Planning Commission

Staff Report

Case No:	13ZONE1015
Project Name:	Spring Villa
Location:	Multiple addresses along S Watterson Trail, Villa Spring Dr, Parker Grant Ct, and Brett Frazier Dr. (Tax Block 0637, Lot 0004)
Owner:	Citizens Union Bank
Applicant:	Citizens Union Bank
Representative:	Bill Bardenwerper; Mindel, Scott and Assoc.
Jurisdiction:	Louisville Metro
Council District:	23 – James Peden
Case Manager:	Joseph Reverman, AICP, Planning Supervisor

- Change in Zoning from R-5A, Multi-Family Residential, to PRD, Planned Residential Development District on multiple addresses along S Watterson Trail, Villa Spring Dr, Parker Grant Ct, and Brett Frazier Dr. (Tax Block 0637, Lot 0004) containing 36.90 acres
- Revised Detailed District Development Plan
- Major Preliminary Subdivision Plan
 - Sidewalk Waiver of Chapter 5.8.1. of the Land Development Code to waive the requirement for sidewalks to be constructed along S Watterson Trl adjacent to the subject site

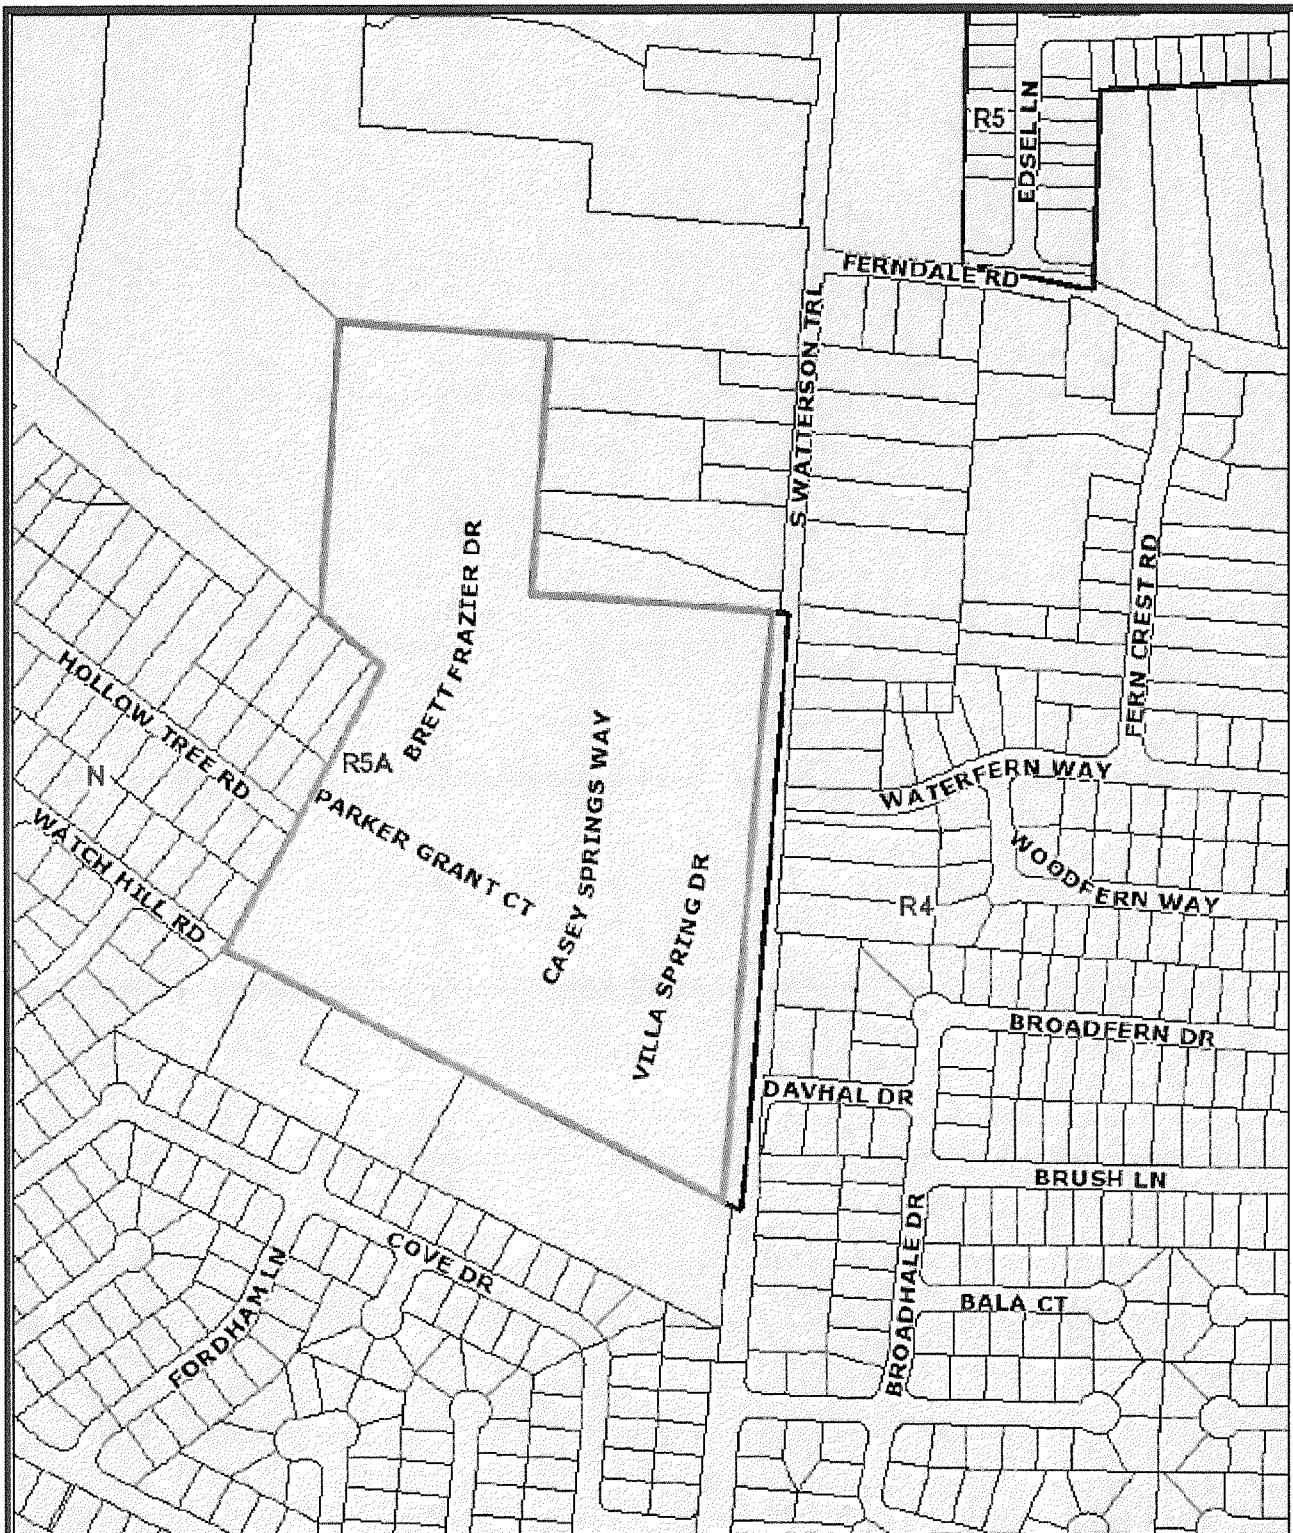
Staff analysis shows that the Planning Commission should consider whether the reduction in the 50 ft LBA along portions of the perimeter property lines would compromise compliance with Guideline 3, Compatibility of the Comprehensive Plan, and that the proposal appears to comply with all other Guidelines and Policies of the Comprehensive Plan.

Staff analysis shows that the proposed reduction of the 50 ft LBA, as described in the staff analysis for the zoning change, could affect compatibility of the proposal with existing development in the area. It appears this 50 ft LBA could be provided, at least on portions of the site, to respect the agreement with the previous rezoning proposal.

Staff analysis shows that the sidewalk waiver does not meet the standards for granting a sidewalk waiver established in the Land Development Code.

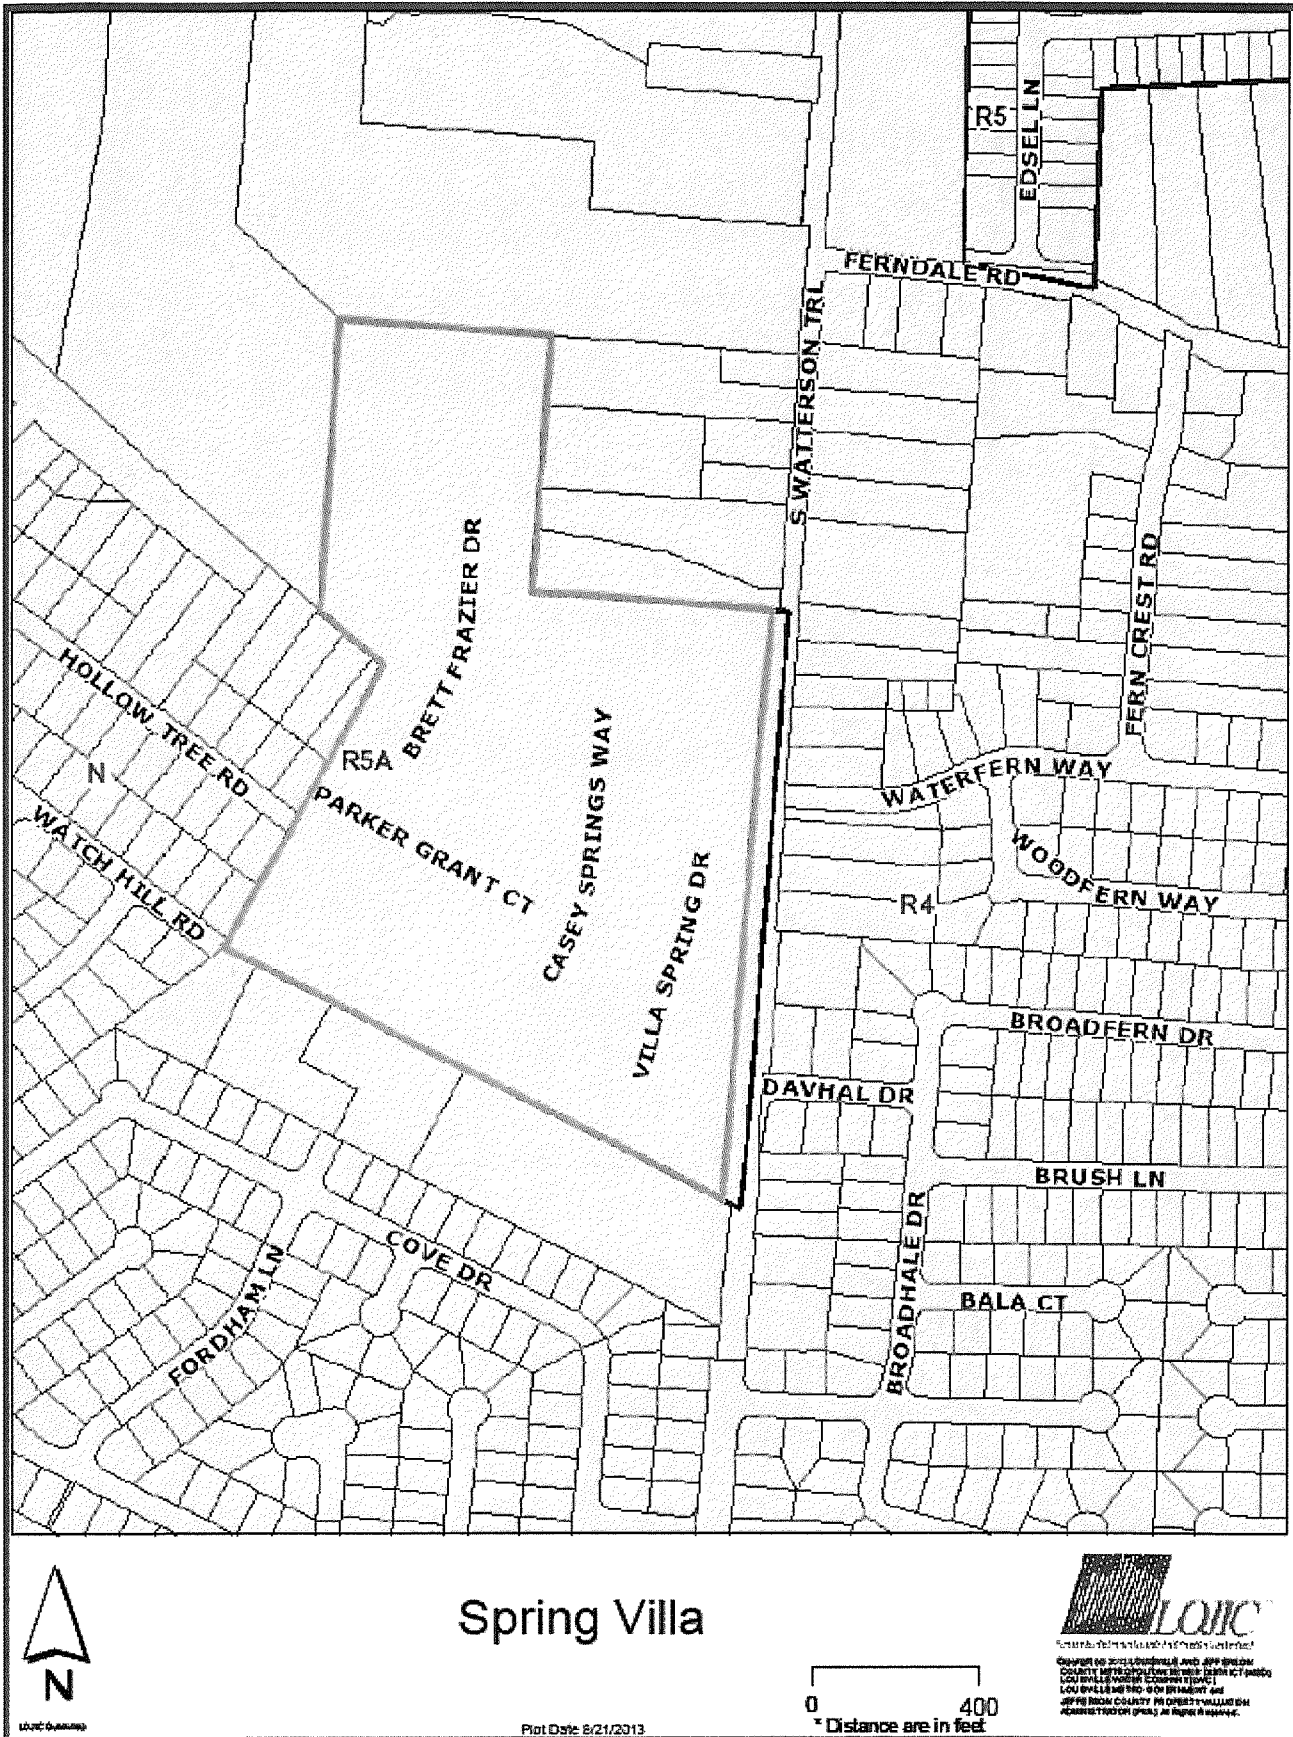
The proposal shows the same number of unites approved with the rezoning under docket number 9-38-01.

The applicant is requesting to reduce the 50 ft LBA shown on the previous approved development plan along a portion of the perimeter of the site to 30 feet.

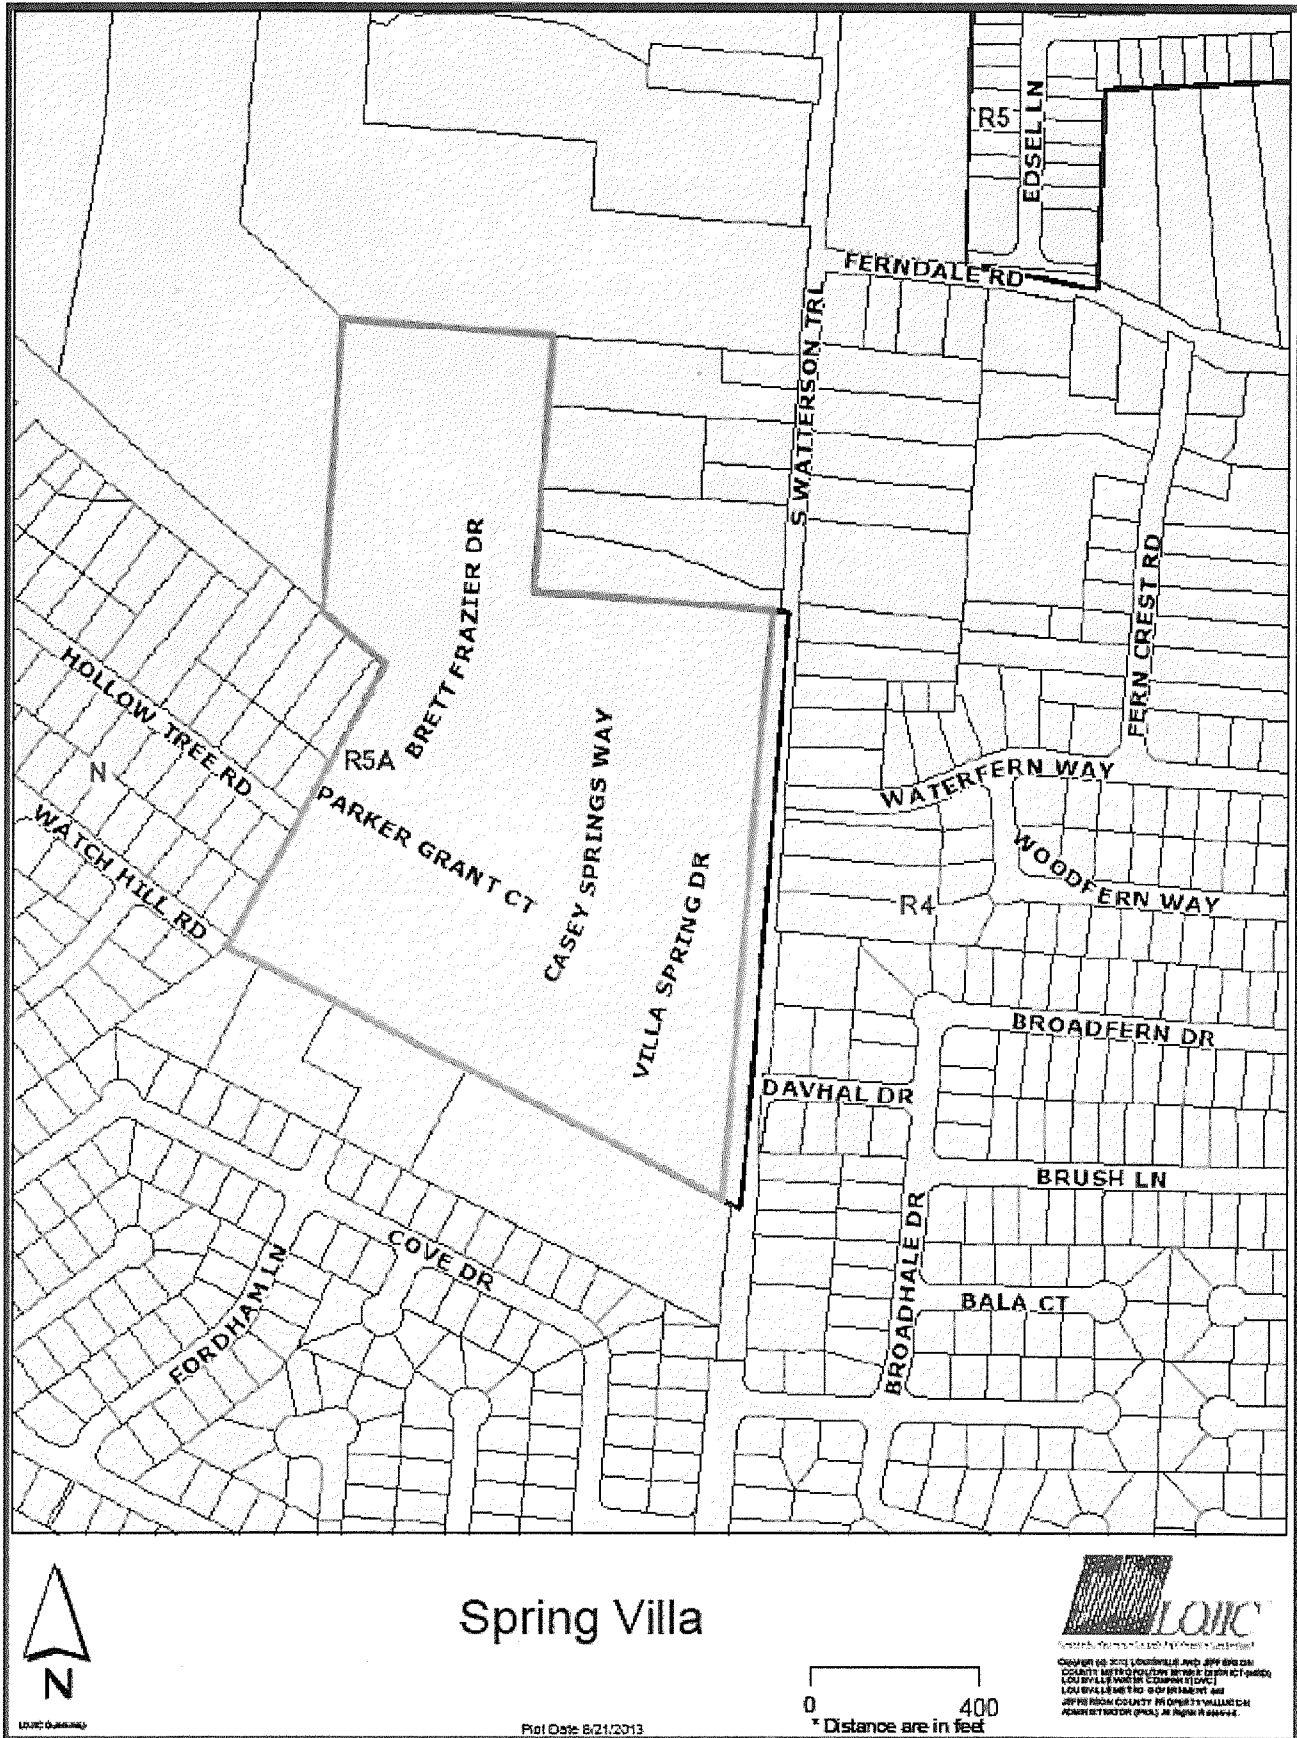
There appear to be some minor changes to the proposed street network from the previous approved development plan. **Guideline 7, Circulation**, and **Guideline 8, Transportation Facility Design** encourage connections to adjacent properties where appropriate to reduce traffic on the main thoroughfare. Connections or stubs to adjacent properties should be provided where possible to encourage cross access and support the development of adjacent lands. Also, sidewalks should be provided throughout the development to enhance pedestrian connectivity.

All other agency comments should be addressed to demonstrate compliance with the remaining Guidelines and Policies of Cornerstone 2020.
